From: DOROCINSKA Ania  
Sent: Friday, 8 January 2016 8:15 AM  
To: 'Hayley Beaton'  
Subject: 59 Woodgee Street Currumbin  
Attachments: 160106 ANEF Woodgee Street.jpg

**MCU201501893 PN338/01/DA2**

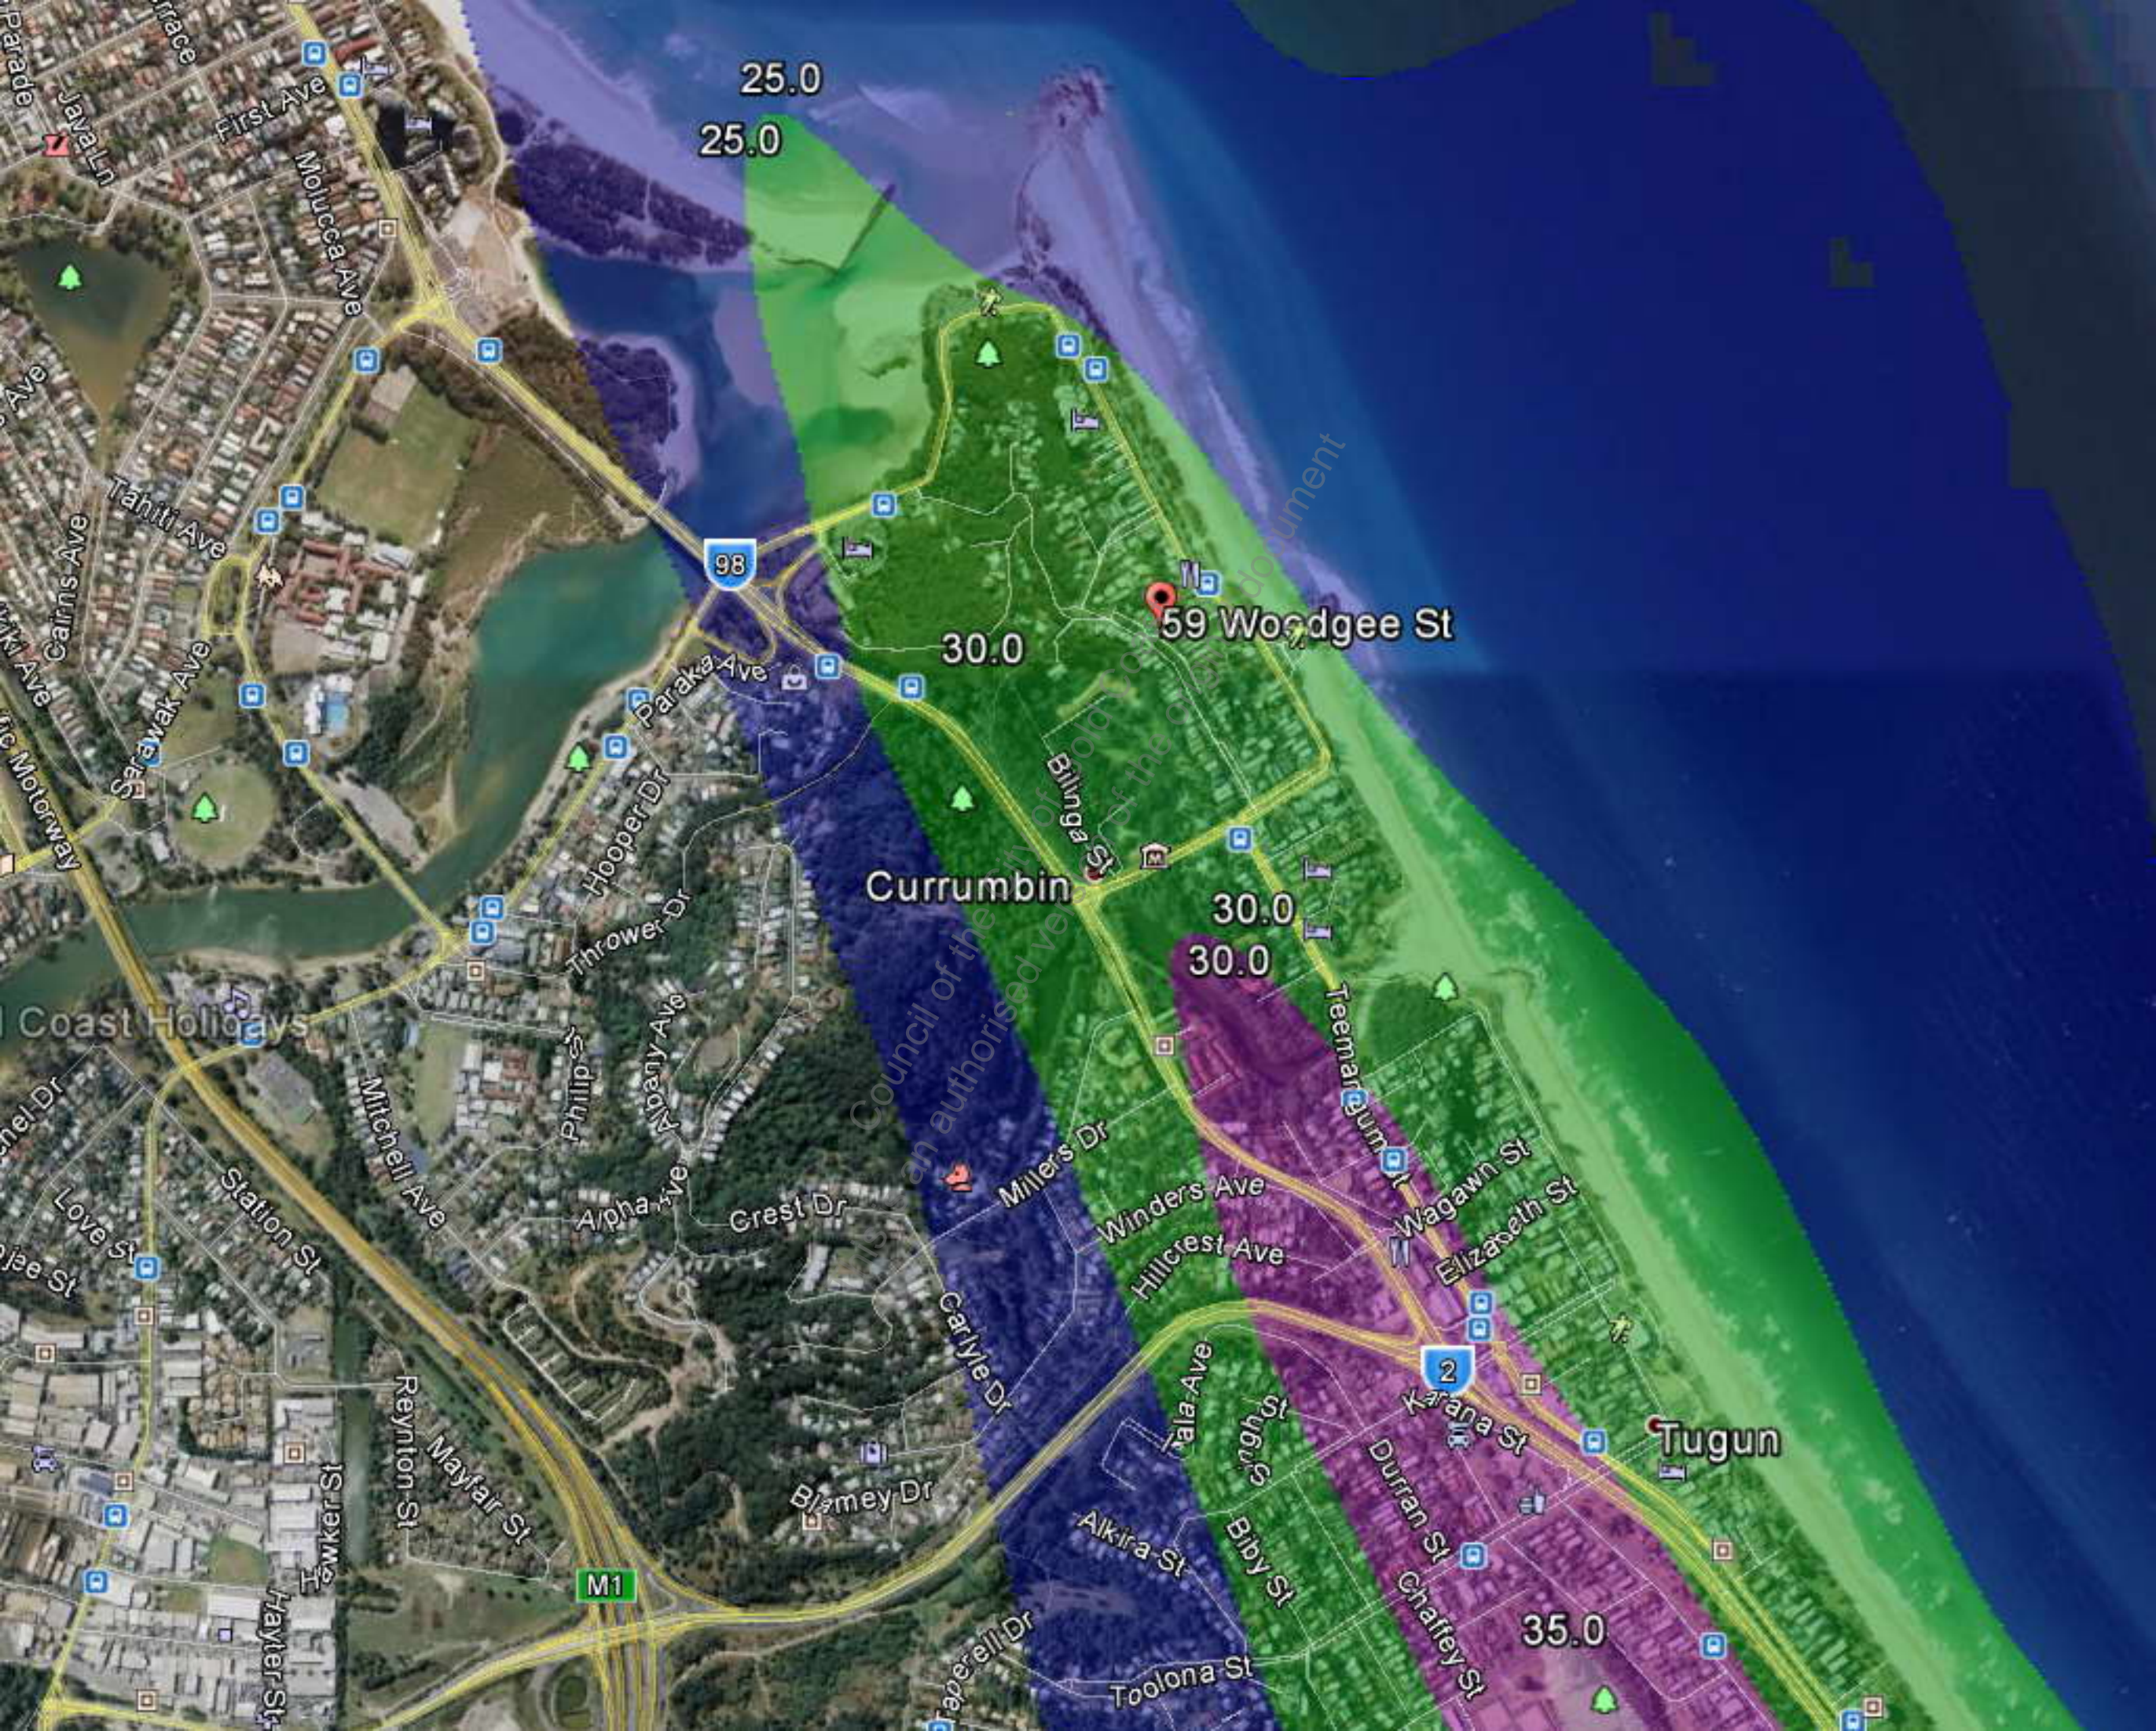
The application documents suggest that the site is between the 20 and 25 ANEF contours. However, that was indeed the case at the time of the previous application in 2007-2009, but in the current 2013 ANEF which has been in place since May 2012, the site is between the 25 and 30 contours, and hence subject to potentially increased intensity of aircraft noise. An image showing the site's position within the ANEF is attached for your information (the green area being the 25-30 zone).
